ADDENDUM NUMBER 1

NOTIFICATION DATE:	BID TITLE:	BID NUMBER:	BID OPENING DATE & TIME:
03/15/12	5th Avenue North Improvements	024/12	04/03/12 2:00PM

This is an addendum following the non-mandatory pre-bid meeting held on March 8, 2012. Based on the discussion, the specifications have been modified to address the following below. Additionally, the attendance list and hand-outs provided at the pre-bid are attached.

SHEET TITLE: PLANTING PLAN 1

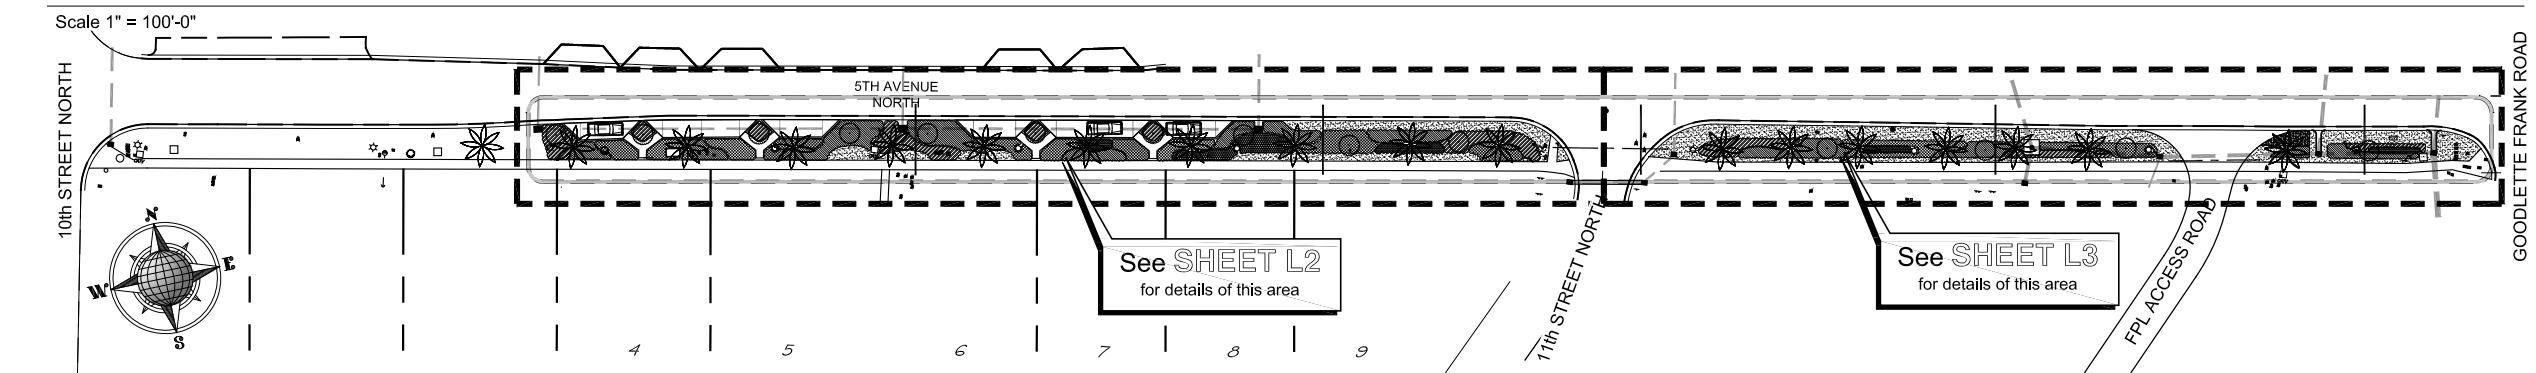
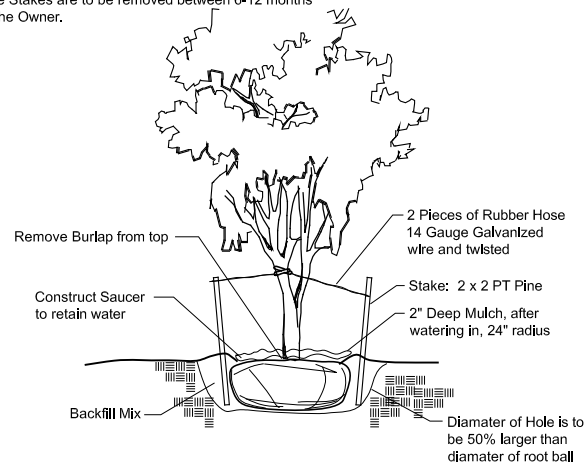
- 8) *Sheet L1 of 6: bottom right side of the Plant list it indicates for us to "Mow the sod 46 times per yr" & to "Mulch on an annual basis, replenish areas as necessary"*

Under the scope there is no mention of the contractor maintaining the project for any length of time.

This language was removed in the revised drawings.

NO.	DATE	DESCRIPTION	DESIGN
1	03.15.12	Revised Mulch Note	C.A.
			tpb
			AS SHOWN
			AS SHOWN
			349

SHEET TITLE: IRRIGATION PLAN 1
 PLANSET TITLE: LANDSCAPE PLANS
 PROJECT NAME: 5TH AVENUE NORTH ROW IMPROVEMENTS

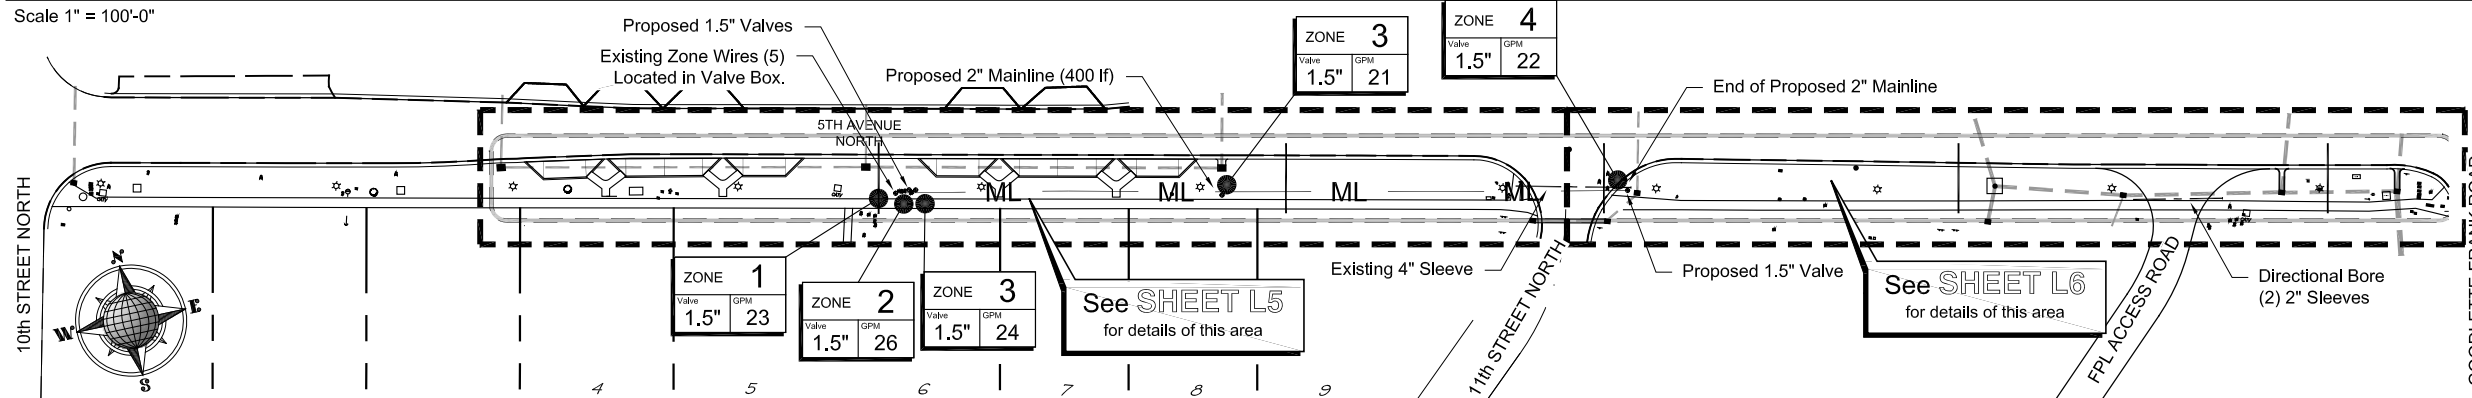
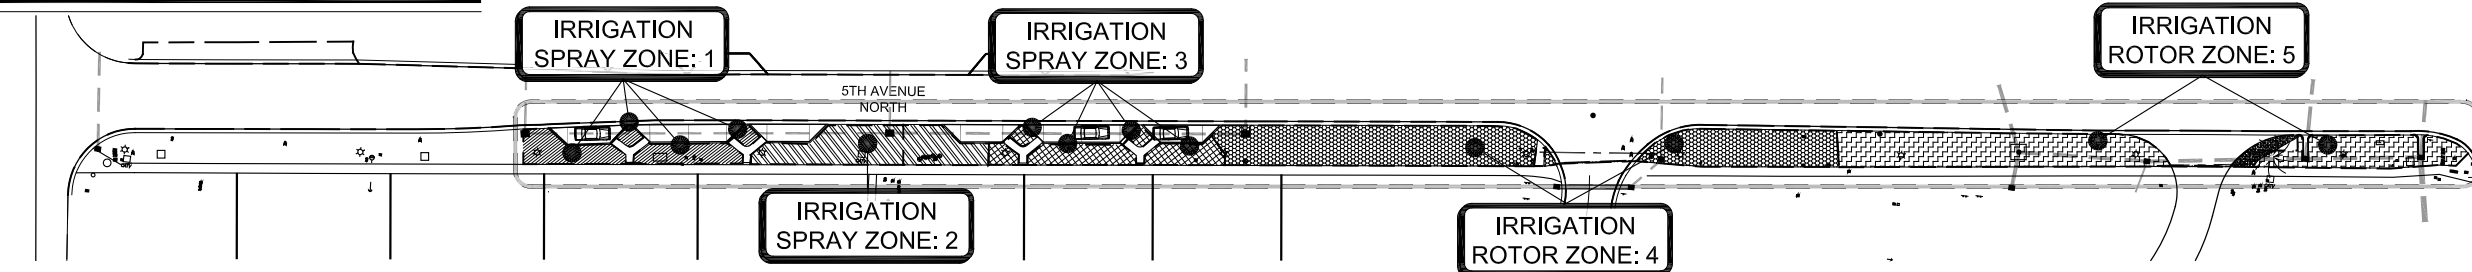
2) *How will water for irrigation be provided?*

There is an existing 2" reuse water line available which has enough capacity for the landscaping. The plans and specifications will address this concern.

NO.	REVISIONS	DATE	DESIGNER
1	Revised Notes	03.15.12	kp

SHEET TITLE:	IRRIGATION PLAN 3
PLANSSET TITLE:	LANDSCAPE PLANS
PROJECT NAME:	5TH AVENUE NORTH ROW IMPROVEMENTS

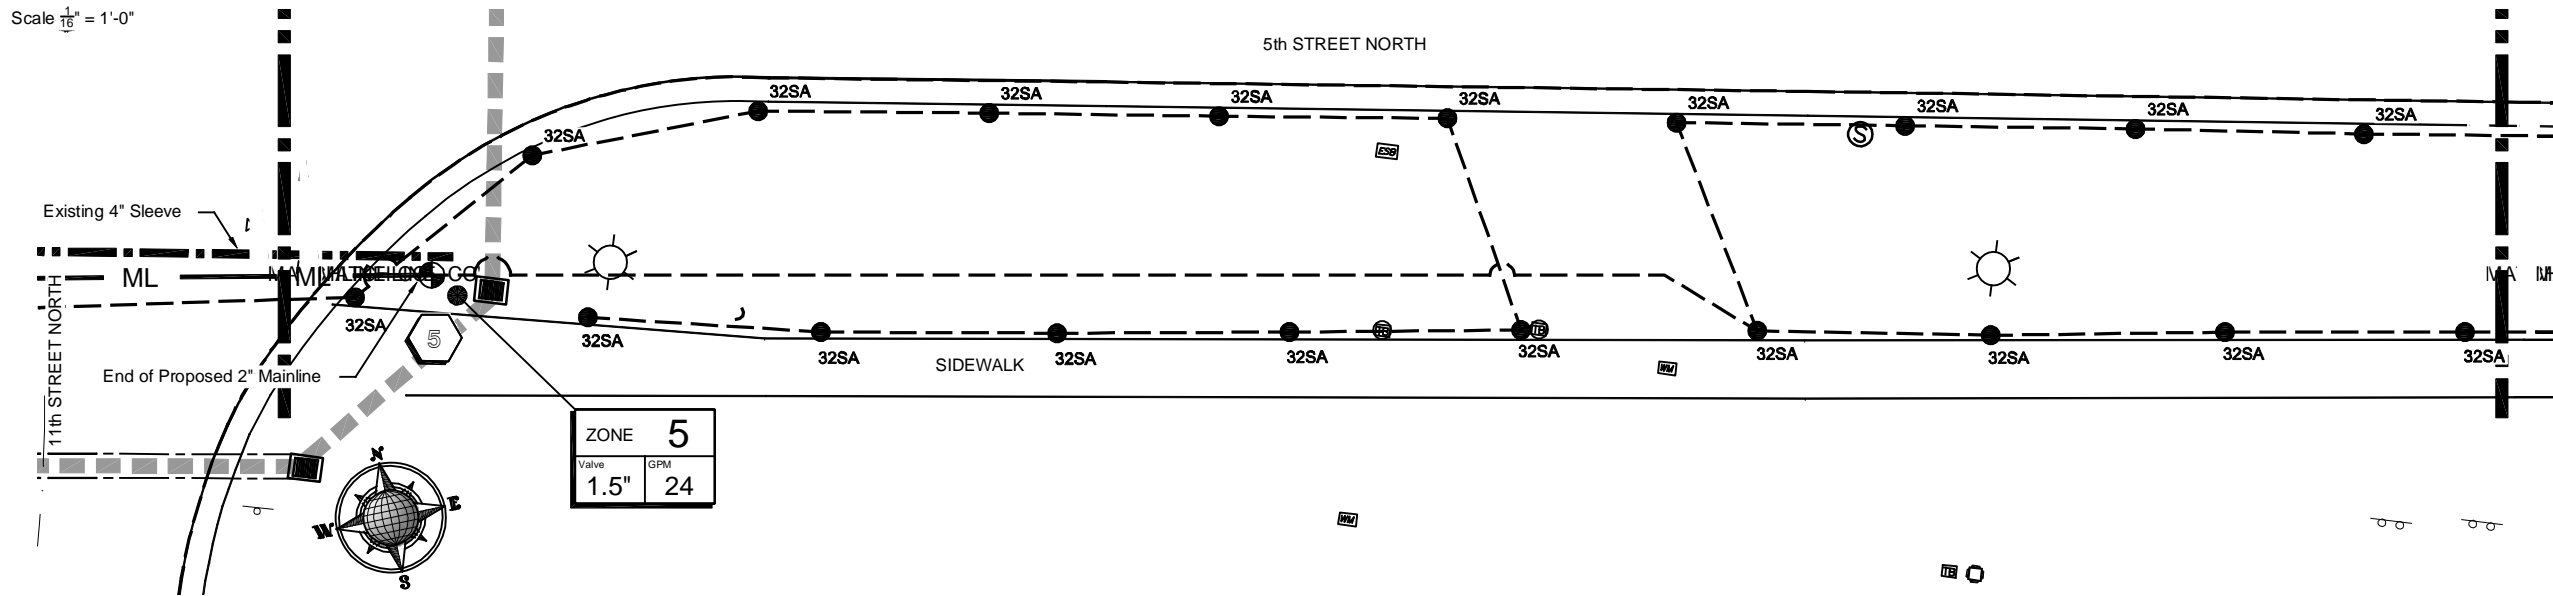
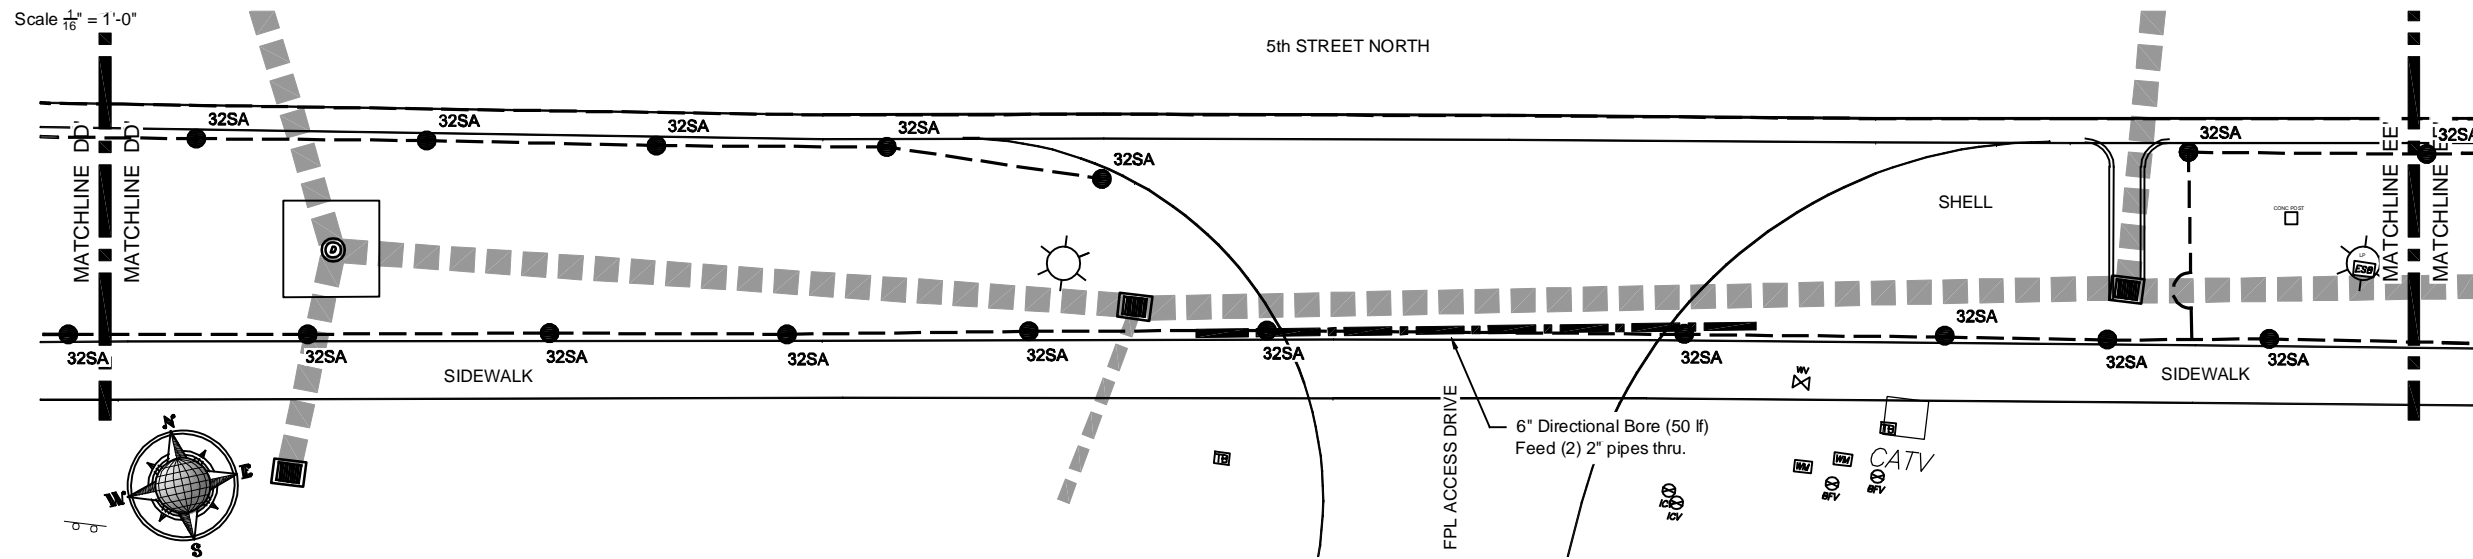
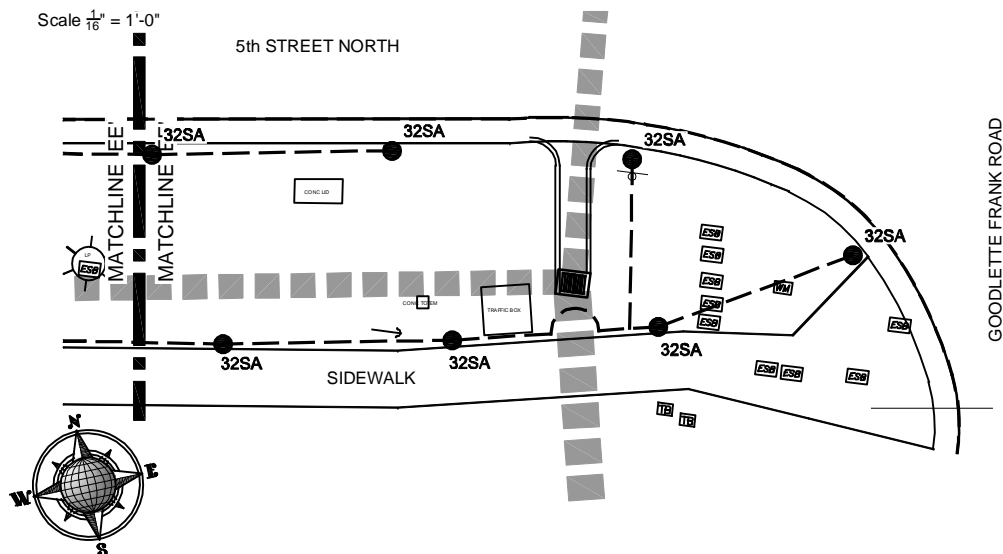
- 7) *Sheet L6 of 6, is showing the last 2 existing catch basins to flumes poured from the toad to the catch basin, design plans do not indicate this work to be done.*

The flumes from EOP to CB's are existing and not part of the Project. The easterly one is hard to see but it is just west of the "No Turn on Red" sign
